MARYSVILLE
COMMUNITY
DEVELOPMENT

Re: Linscott Short Plat pre-application, 9622 48th Dr. NE, WA 98270 (PREA21-042)

PREA21-042 Linscott Short Plat

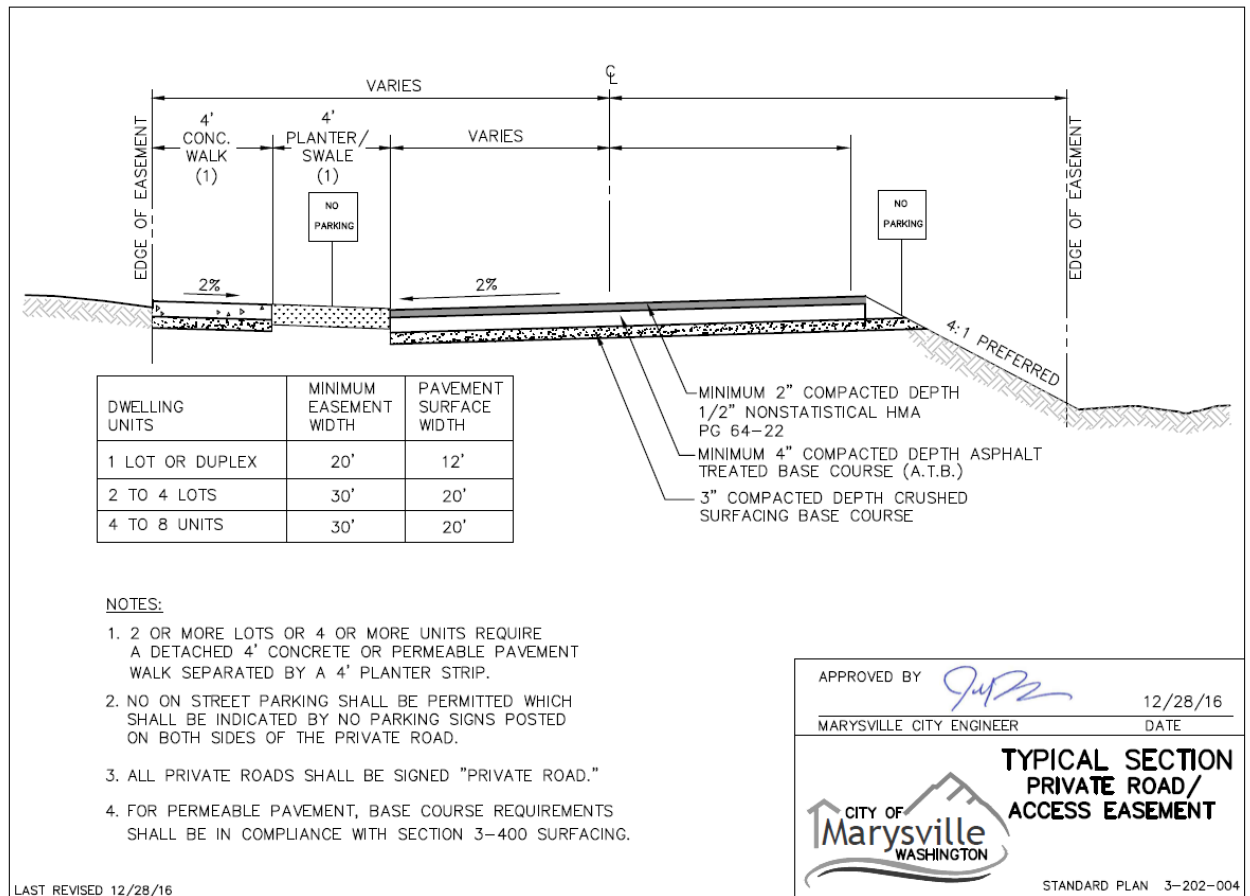
- a. The access road will need to be compliant with the drawing provided below. When serving 2 or more lots a 30 foot easement is required.
